SYDNEY WESTERN CITY PLANNING PANEL

Panel Reference	2017SSW003
DA Number	1471/2016
Local Government Area	Camden
Proposed Development	Construction of two (2) x seven (7) storey residential flat buildings, containing 156 residential units and two (2) basement levels containing 191 carparking spaces, landscaping and associated works on proposed Lot 2 in a resubdivision of 28 Ingleburn Road.
Street Address	28 Ingleburn Road, Leppington
Applicant/Owner	Balintore Ingleburn Pty Ltd C/O Design Cubicle Pty Ltd Balintore Ingleburn Pty Ltd
Number of Submissions	Six (6) objections were received.
Recommendation	Refusal
Regional Development Criteria (Schedule 4A of the EP&A Act)	Capital investment value >\$20 million CIV - \$34,846,636
List of All Relevant s79C(1)(a) Matters	<ul style="list-style-type: none"> • State Environmental Planning Policy (State and Regional Development) 2011 • State Environmental Planning Policy (Sydney Region Growth Centres) 2006 • State Environmental Planning Policy No 55 – Remediation of Land • State Environmental Planning Policy No 65 – Design Quality of Residential Apartment Development • State Environmental Planning Policy (Building Sustainability Index: BASIX) 20

Image 6 – South west elevation (Road No. 2)

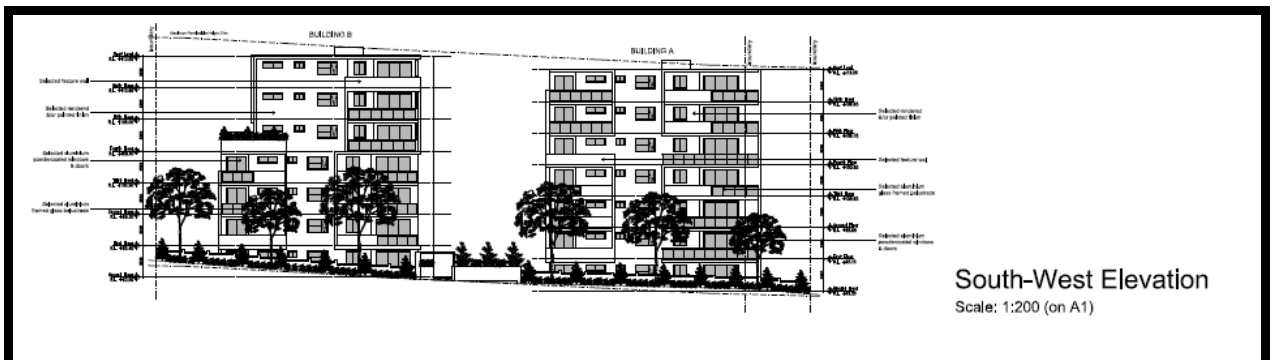
In addition, the proposed continuous seven (7) storey street wall proposed along the 20m residential collector road is a not an acceptable built form for the subject site and the desired future streetscape as it does not provide a ‘ human scale ’ to the development. A two (2) – four (4) storey wall height across the site, with a secondary setback above the podium without any protrusions would allow a pedestrian-friendly streetscape and reduce overshadowing to adjoining streets and lots.
